**ARCHITECTURAL REVIEW BOARD
CITY OF FREDERICKSBURG, VIRGINIA
AGENDA
May 9, 2016
7:30 P.M.
COUNCIL CHAMBERS, CITY HALL**

ARCHITECTURAL REVIEW BOARD

May 9, 2016

Bond's Drug Store, c.1924

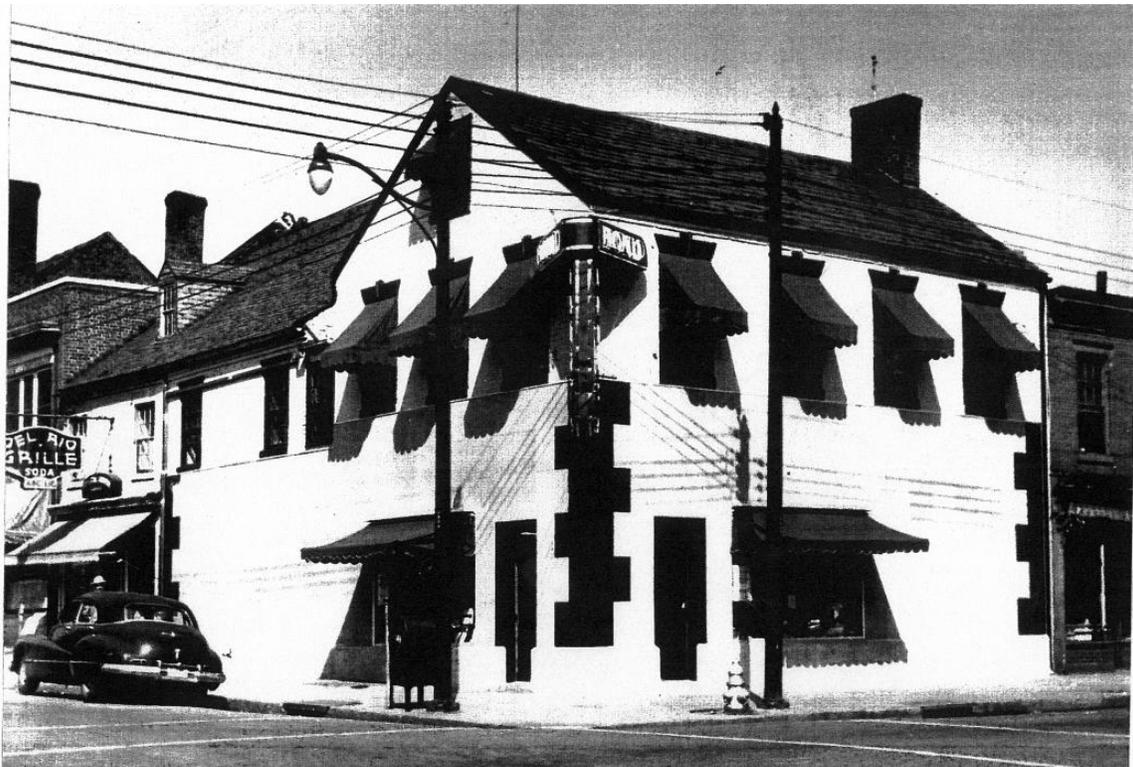
Note that the gap between 201 and 203 William has been filled and windows appear in this location. Also note the entry door and window configuration on the 203 William building.

A.1
SHEET 1 OF 3

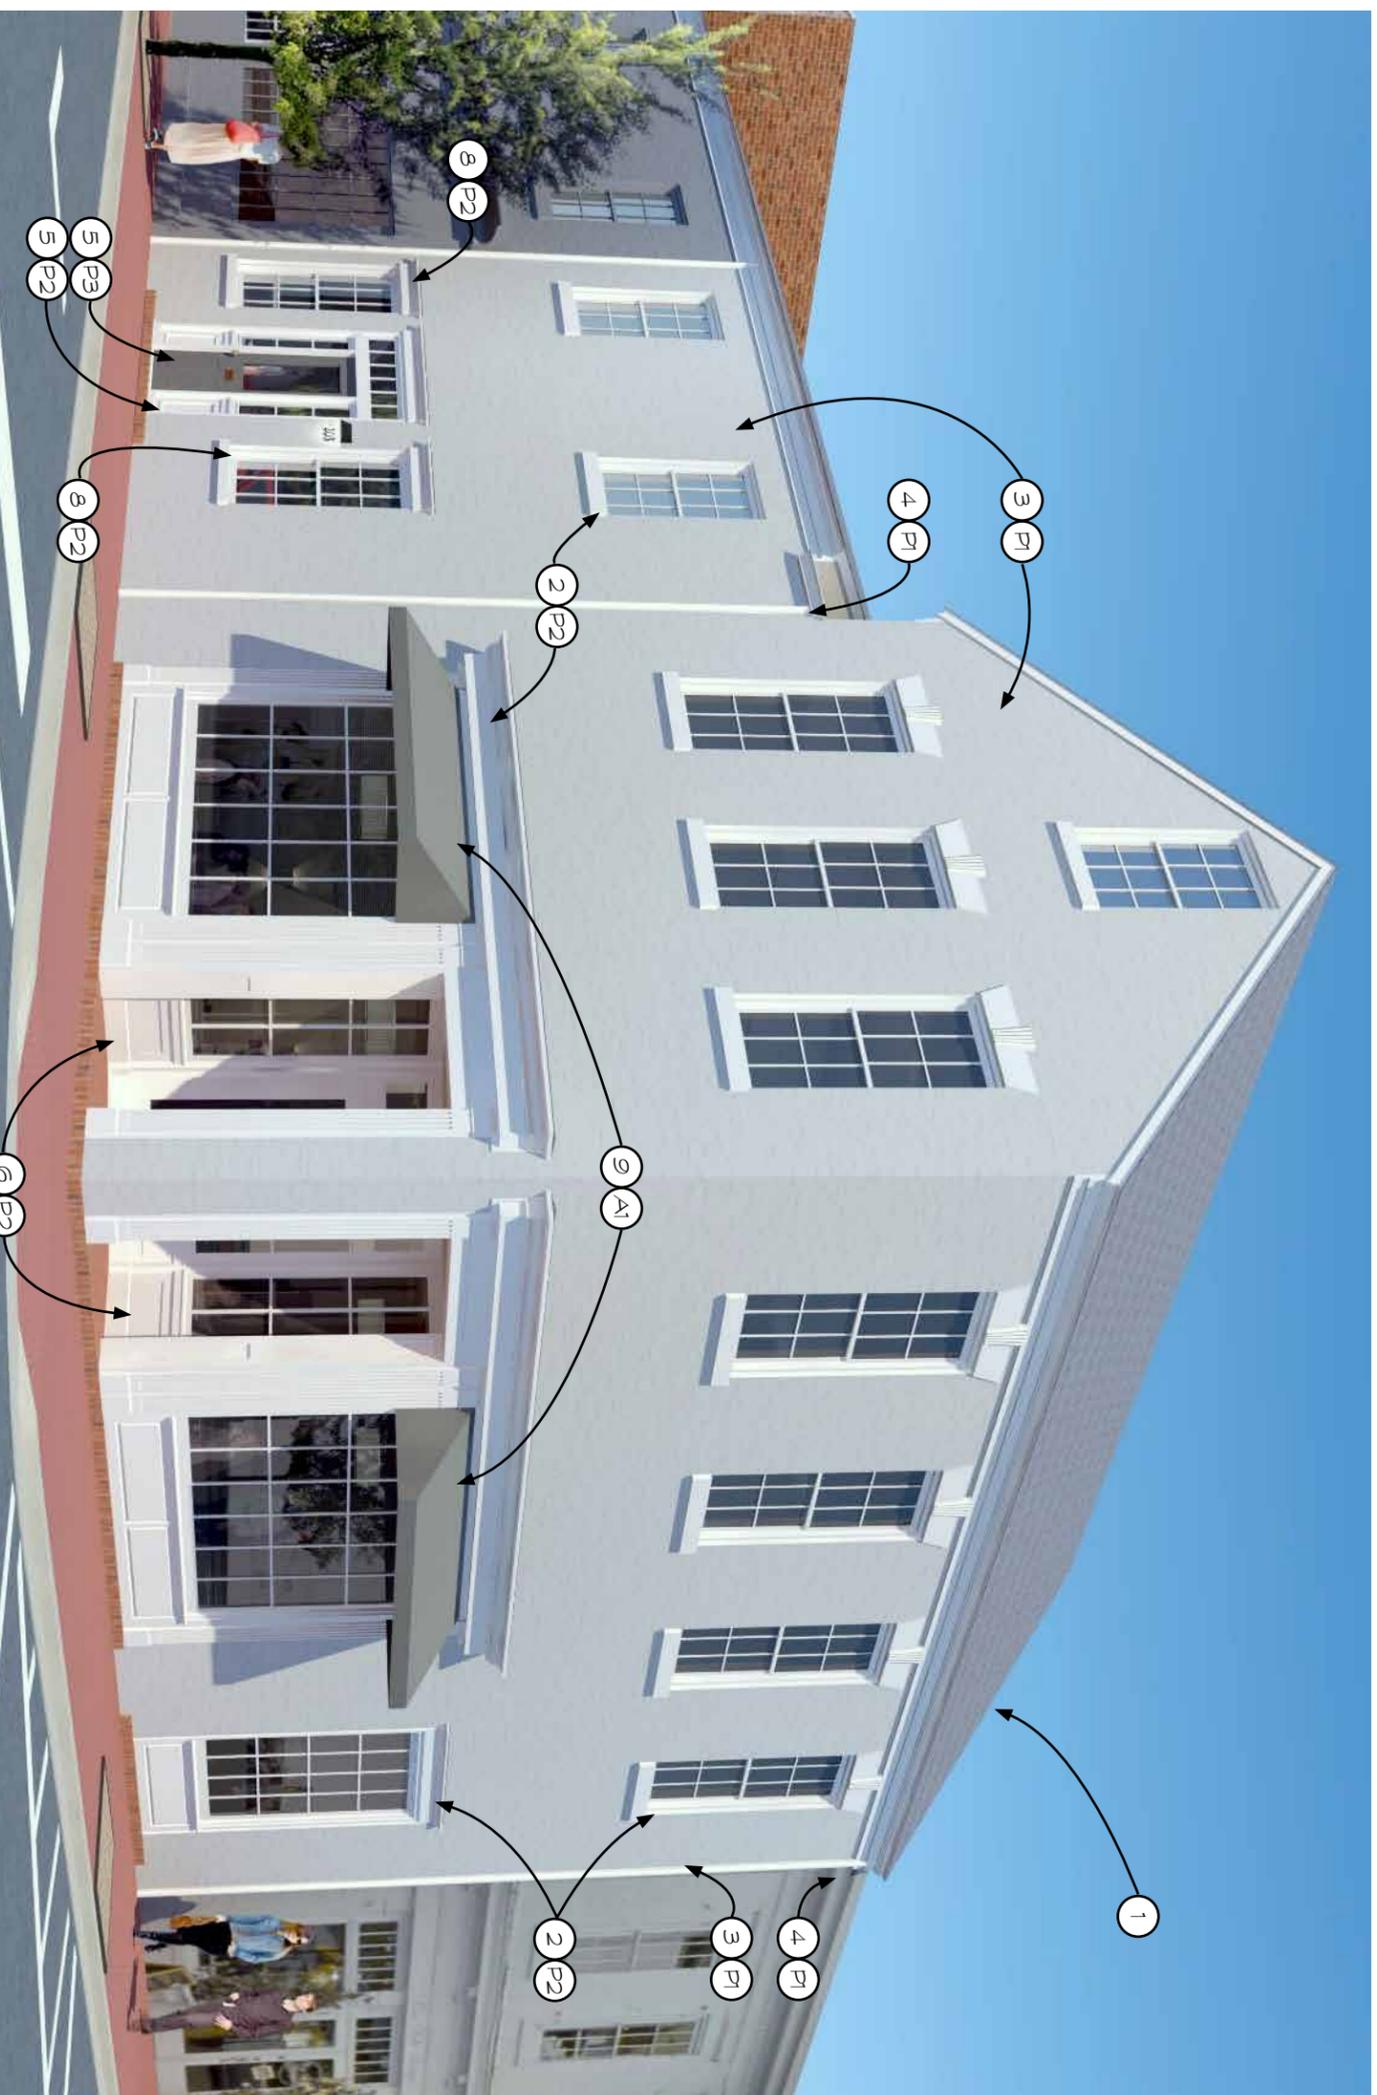
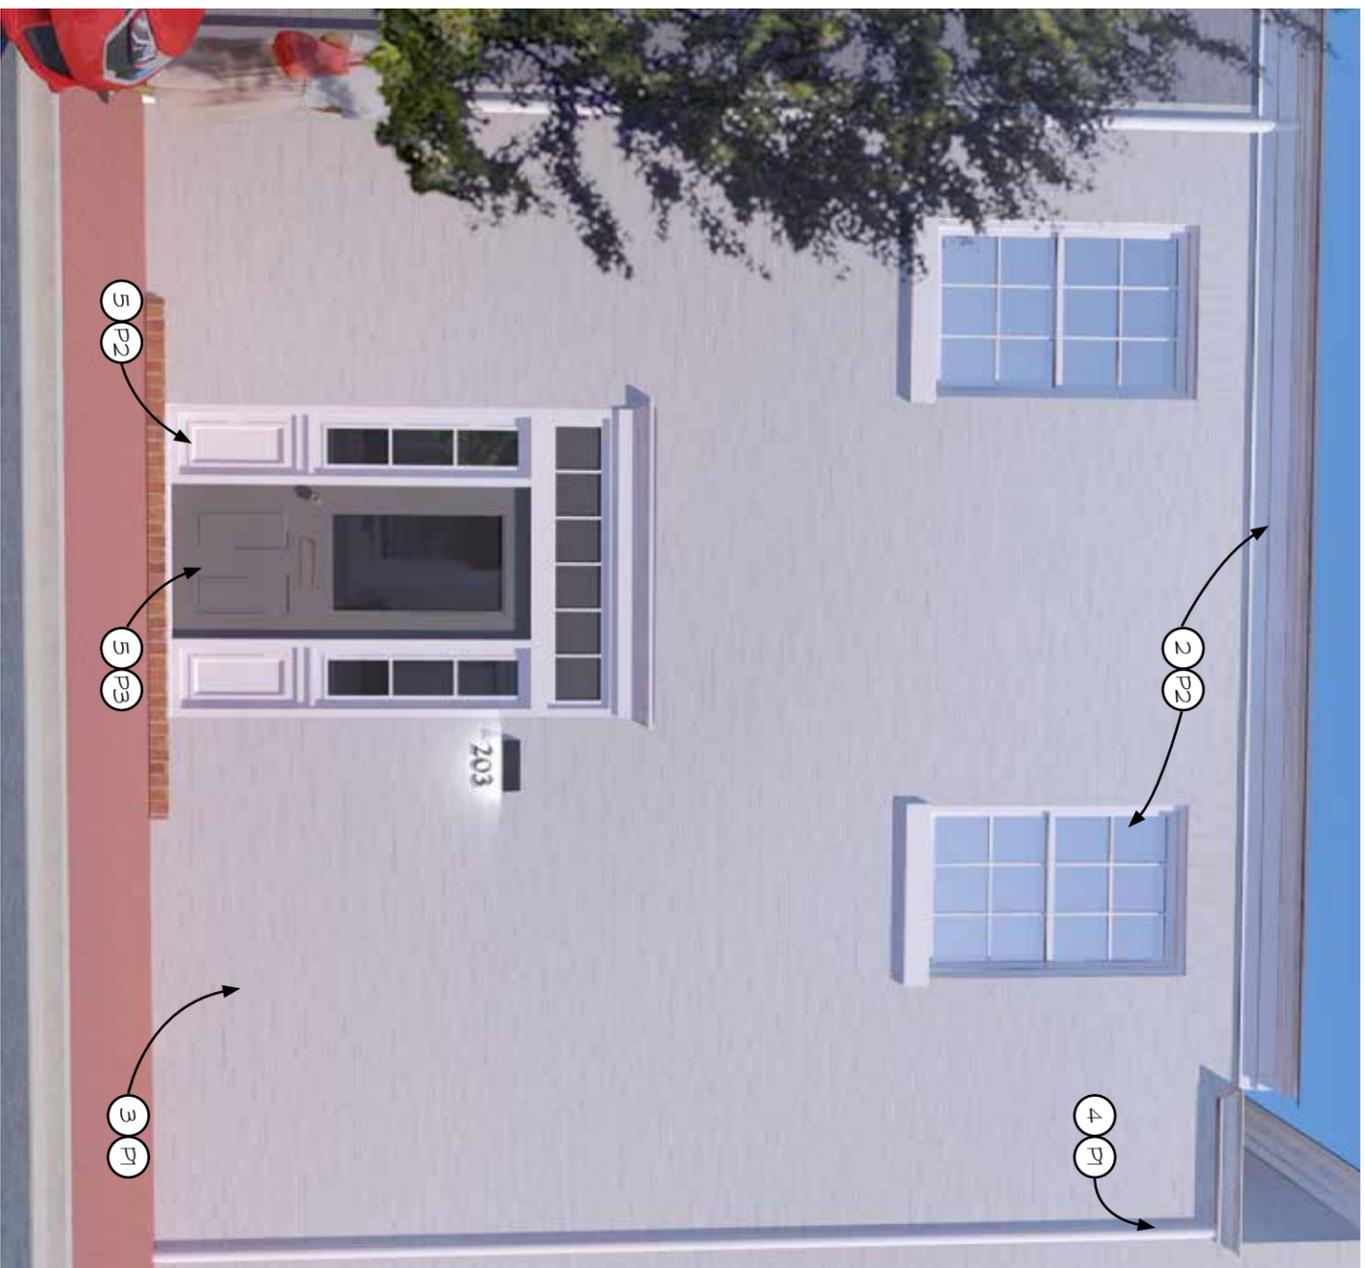
- If repair of the existing slate roof is not feasible, the roof will be replaced with synthetic slate shingles. In the National Park Service’s *Preservation Brief 29: The Repair, Replacement, and Maintenance of Historic Slate Roofs*, the author states, “If 20% or more of the slates on a roof or roof slope are broken, cracked, missing, or sliding out of position, it is usually less expensive to replace the roof than to execute individual repairs. This is especially true of older roofs nearing the end of their serviceable lives.” It is likely that the current roof dates to the original construction of the buildings and has been in place for 191 to 194 years. Synthetic slates have been used successfully within the district; however, staff recommends continuing this request to allow the applicant to provide additional information on the proposed material.

1. Consider repair and patching of slate roof prior to complete replacement with synthetic slate roof shingle. If roof is deemed beyond repair, contact VMS architect for synthetic slate sources that have been accepted in other historic districts in Virginia. Ensure approval of substitute by your municipality prior to purchase of material.
2. **Remove wood shutters. Repair or replace wood trim on first floor storefronts and windows. Prime and paint all trim.

PROPOSED SITE PLAN
TOWNHOMES AT RIVERWALK SQUARE
 506 - 520 SOPHIA STREET FREDERICKSBURG, VA
 03/14/16
A2

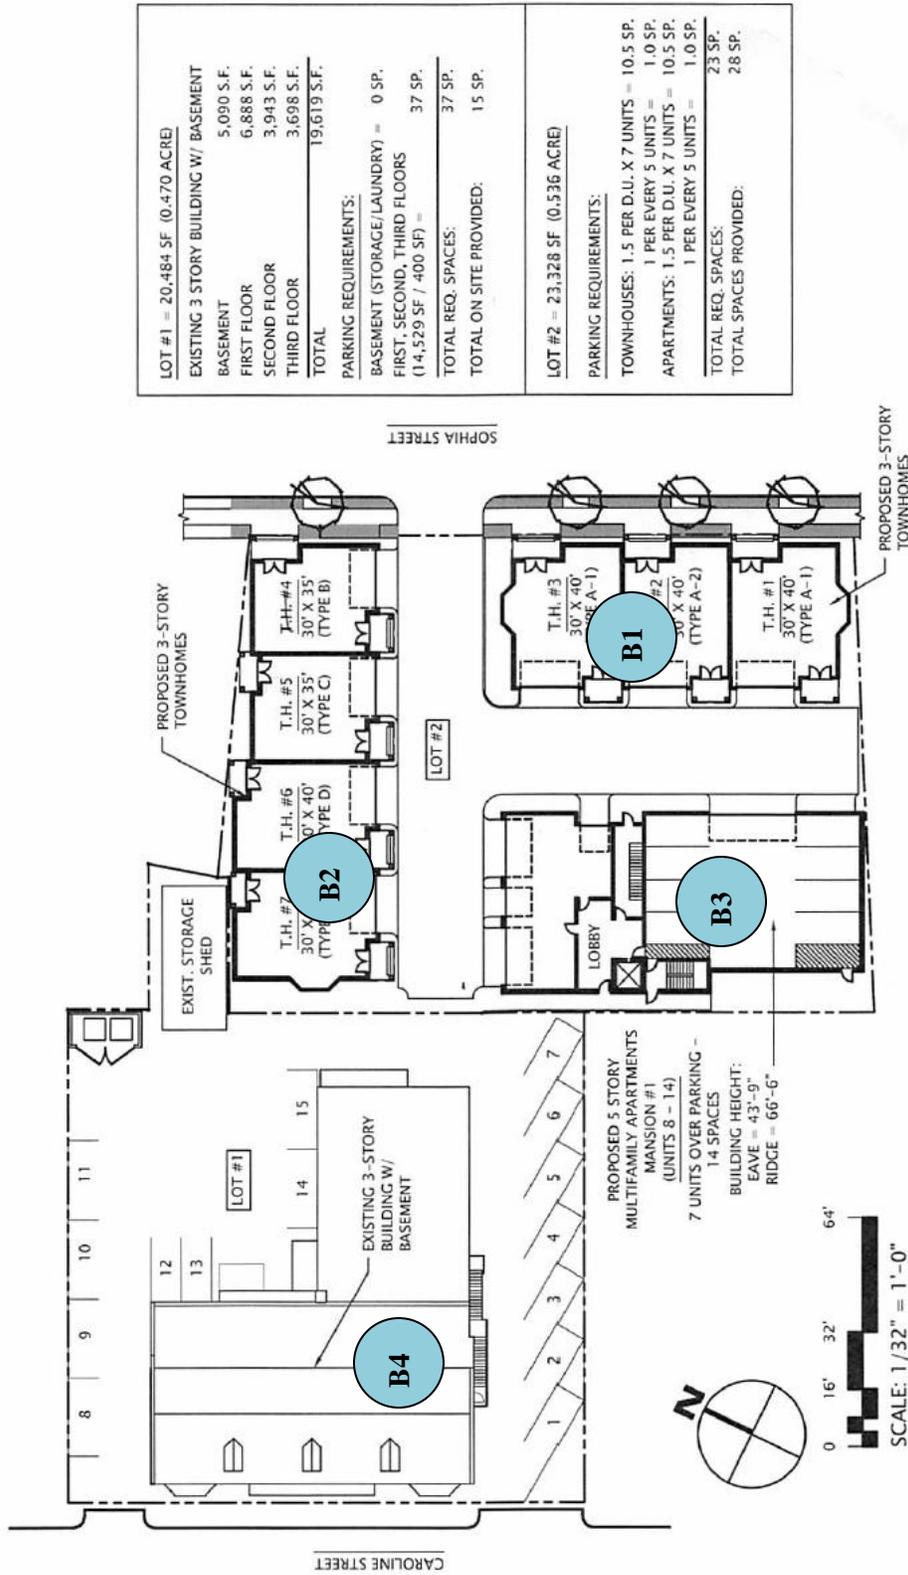
On Sophia Street, one of the proposed new residential structures mimics the existing street edge of the contributing c.1940 dwelling. However, the other two follow the model of the existing non-contributing structures which are not consistent with historic patterns of development. Traditionally, service areas were located towards the interior of the block, with primary structures oriented to the street edge. Access to these service areas was typically provided through alleys, or through drives subordinate to the primary structure. Historic Sanborn Fire Insurance maps clearly show these traditional development patterns (attachments C.1 – C.3). The proposal shows an access drive between the two townhome structures, with one building oriented to this secondary drive, rather than the street.

The 500 block of Caroline Street displays a very high level of integrity in the continuity of the street edge and consistency in the spacing, orientation, and placement of structures. All properties on this block display a zero front setback, and minimal or non-existent side setbacks, with many of the structures attached. The Fredericksburg Square building at 525 Caroline shows the most significant variation from this pattern, with 23 and 31-foot gaps to each side. The two primary areas of concern in the proposed site planning are disruption of the street edge and the location of service areas. The applicant proposes to construct buildings B2 and B3, as shown on attachment A, on the existing service and parking area for the Fredericksburg Square property, forcing those activities closer to the Caroline Street commercial corridor. By eliminating the ability to locate parking, delivery, mechanical, and other related needs on the interior of the block, the proposed project severely limits any future restoration of the Caroline Street frontage. In addition, the historic Sanborn maps show that structures once existed in these gaps (attachment C.3).

Attachment E.1 – EXISTING STREETSCAPE

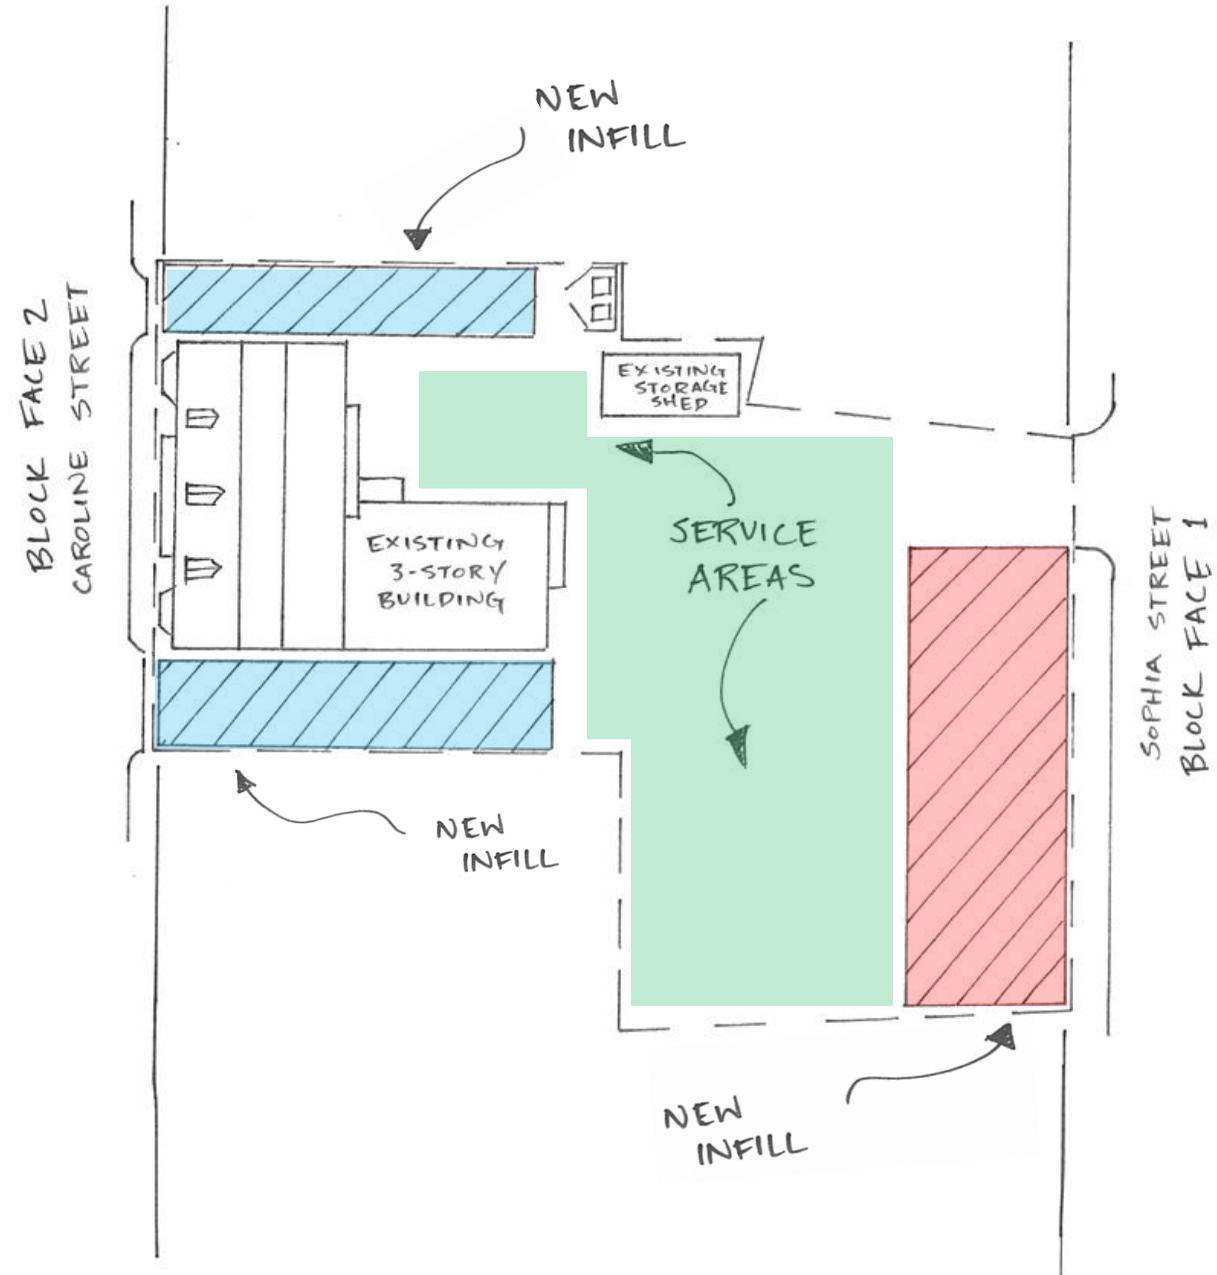
- The majority of properties in the 500 block of Sophia Street show a zero front setback.
- Side setbacks are irregular due to the inconsistent orientation of properties and the presence of parking lots; however, the streetscape is more consistent on the west side of Sophia and historic patterns of development are clear. The parking lot at the rear of 525 Caroline is the only significant gap in the streetscape.
